ADDENDUM NO. 2 TO FINAL ENVIRONMENTAL IMPACT REPORT

MOSQUITO ROAD BRIDGE REPLACEMENT PROJECT

October 2022

Changes to the Proposed Construction Plan for the Project

1. Staging Area and Batch Plant Location Map
2. Route to Syar Concrete Mixing Plant

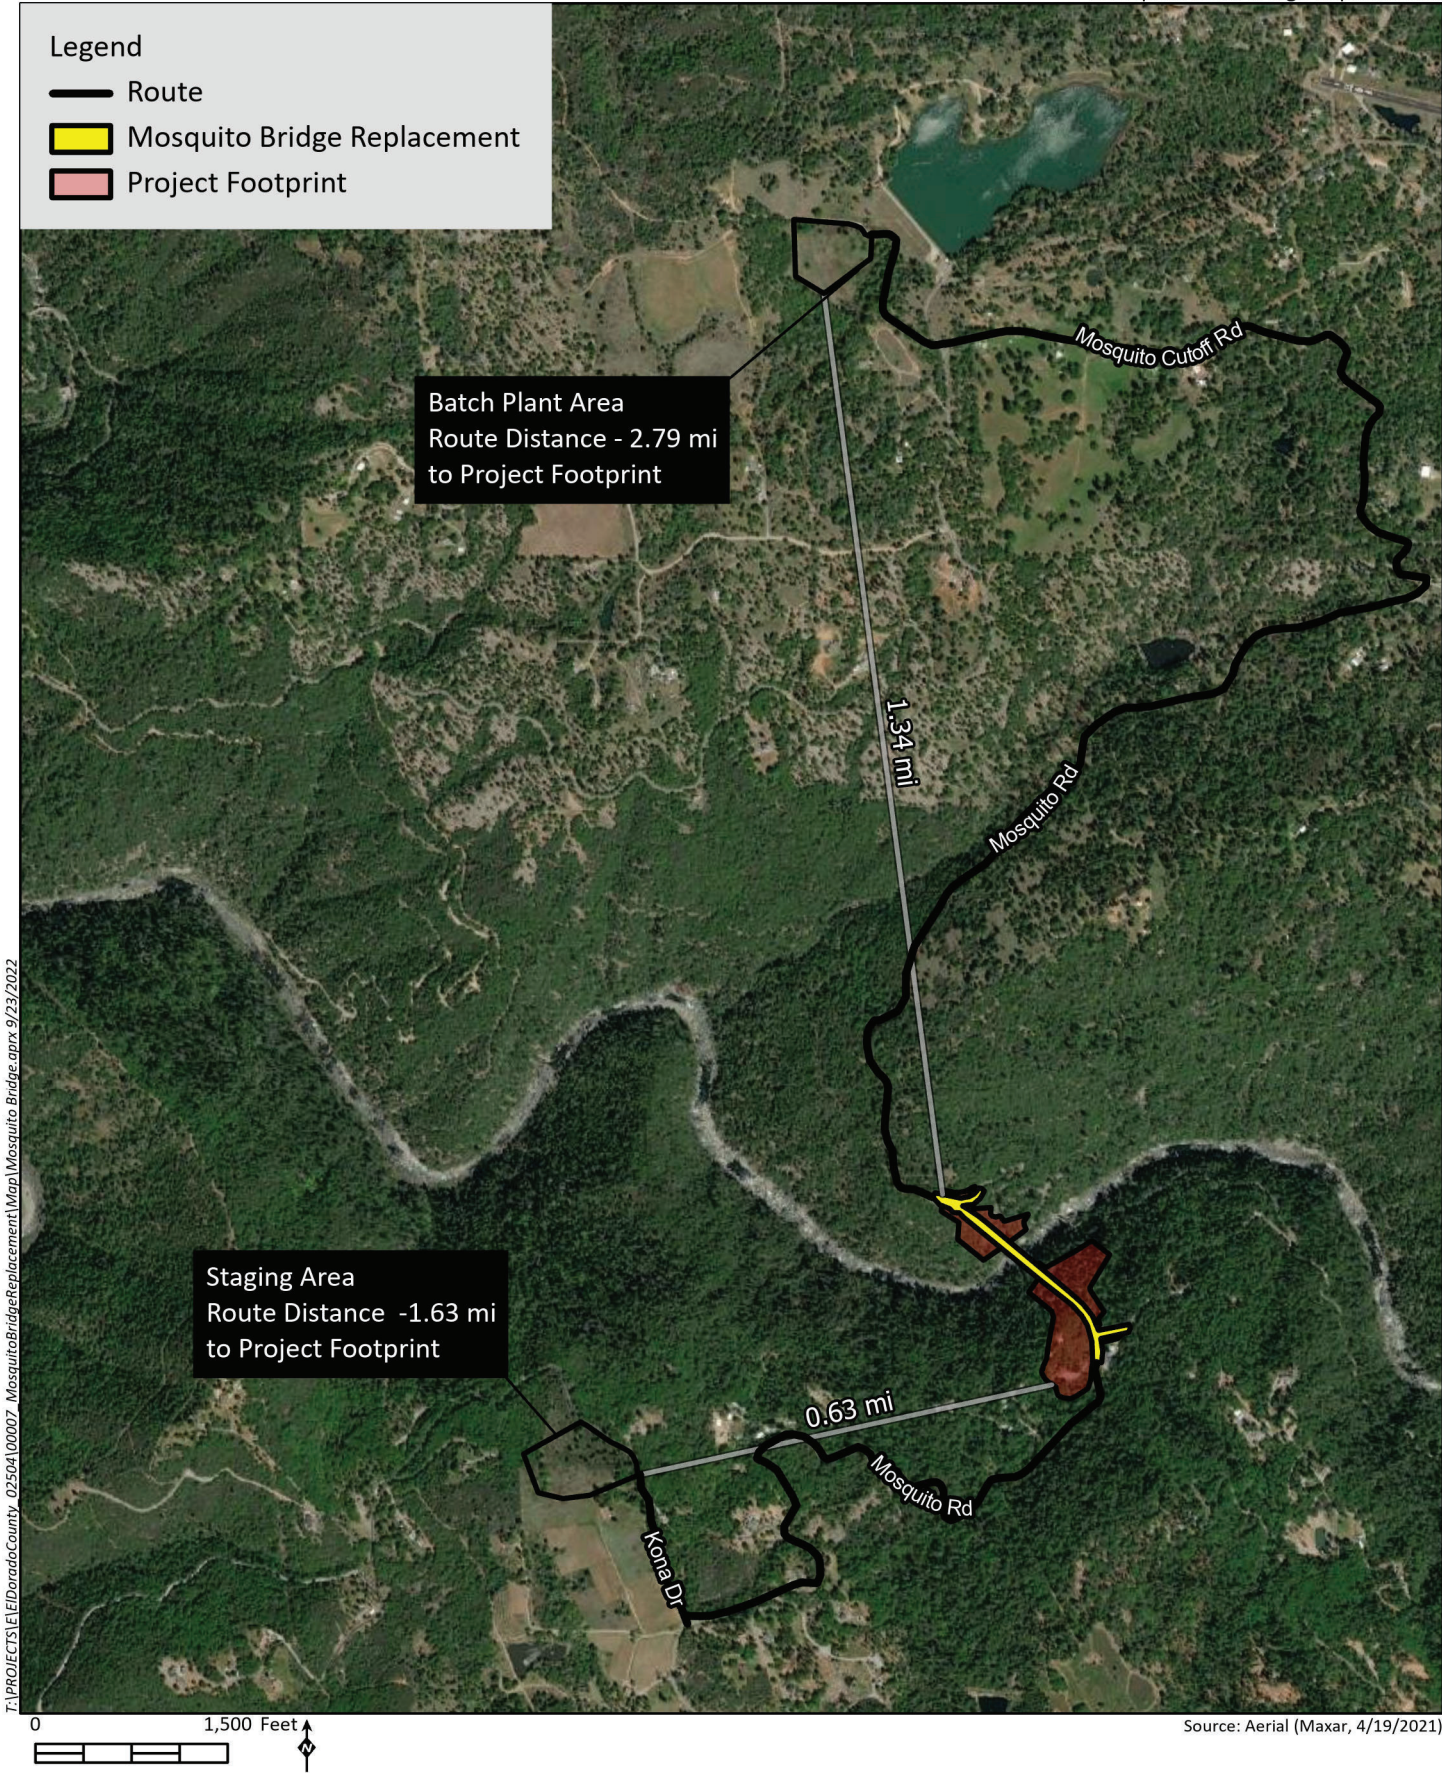
Therefore, the proposed construction plan would be revised to include the temporary siting of a concrete batch plant and construction equipment staging areas in locations that are sufficiently sized to support the project construction needs and are also in close proximity to the proposed Project site. The proposed concrete batch plant area is undeveloped, although two small entry points have been cleared of vegetation and rip rap has been placed. A large, flat gravel pad has been placed within the staging area, and all vegetation in the pad has been removed. The southern portion of the staging area is undeveloped. Both areas would be restored to the previous use after the temporary use during construction is complete and reseeded as necessary. The proposed concrete batch plant and staging areas encompass approximately 14 acres. See Figure 1 which shows the locations of the two areas in relation to the Project site.

Figure 2

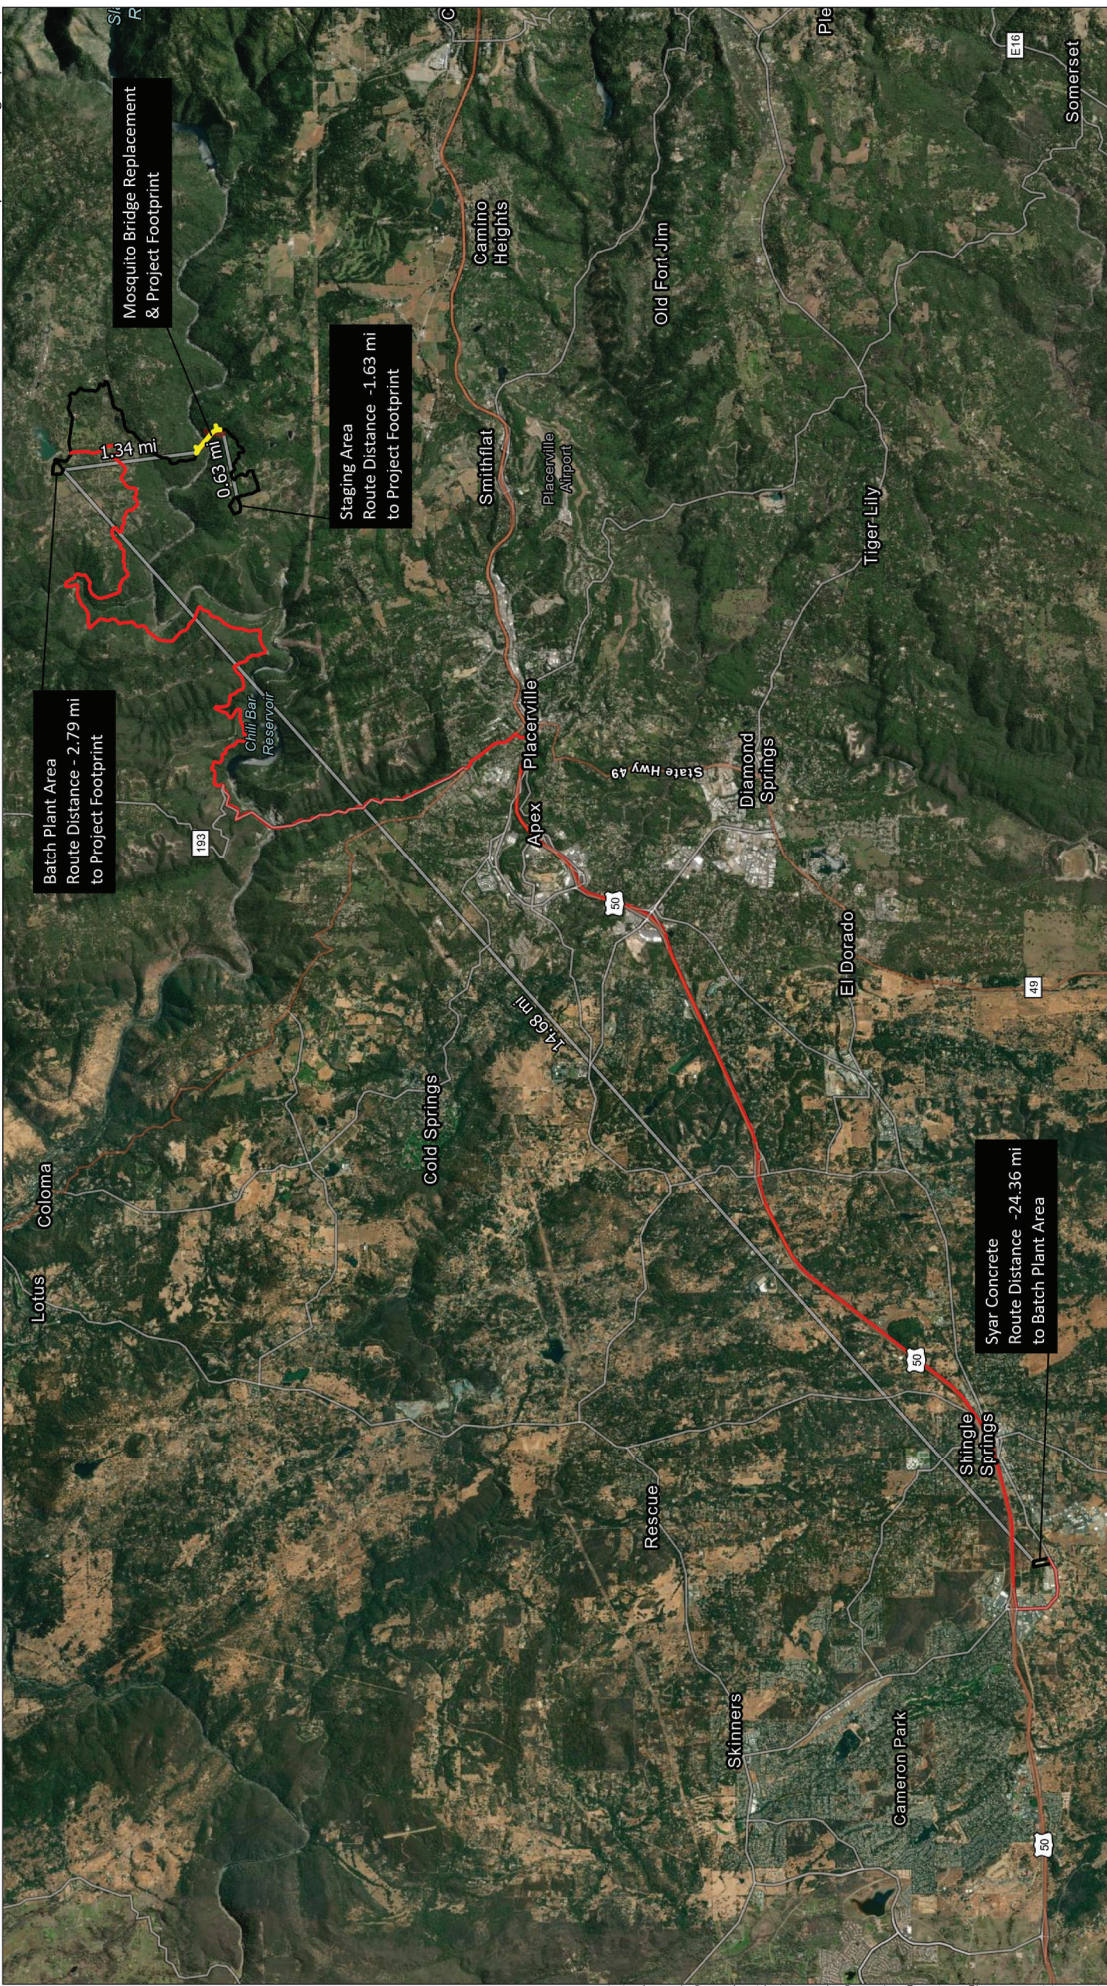
As noted above, the siting of a concrete batch plant near the proposed Project would substantially reduce truck trip distances associated with the original construction plan to transport concrete from the Syar Concrete plant to the Project site. According to the Senior Civil Engineer, Brian Franklin, of El Dorado County Department of Transportation, if the concrete is not supplied by the batch plant proposed near the Project site, it would be supplied by the Syar Concrete plant. The route for the concrete trucks would be via Hwy 50 to Hwy 49 to Hwy 194 to Rock Creek Road to Mosquito Road to the batch plant site. As the route would pass adjacent to the proposed batch plant site, the route from the batch plant site adjacent to Rock Creek Road to the Project would be the same. Based on a Google search for the distances, it is approximately 24.36 miles from Syar Concrete at Shingle Springs to the proposed batch plant location and an additional 2.79 miles to the site, totaling approximately 27 miles. This project construction change would provide a reduction of approximately 54 Vehicle Miles Travelled (VMT) per truck load. See Figure 2 which shows the batch plant location in relation to the Syar concrete plant.
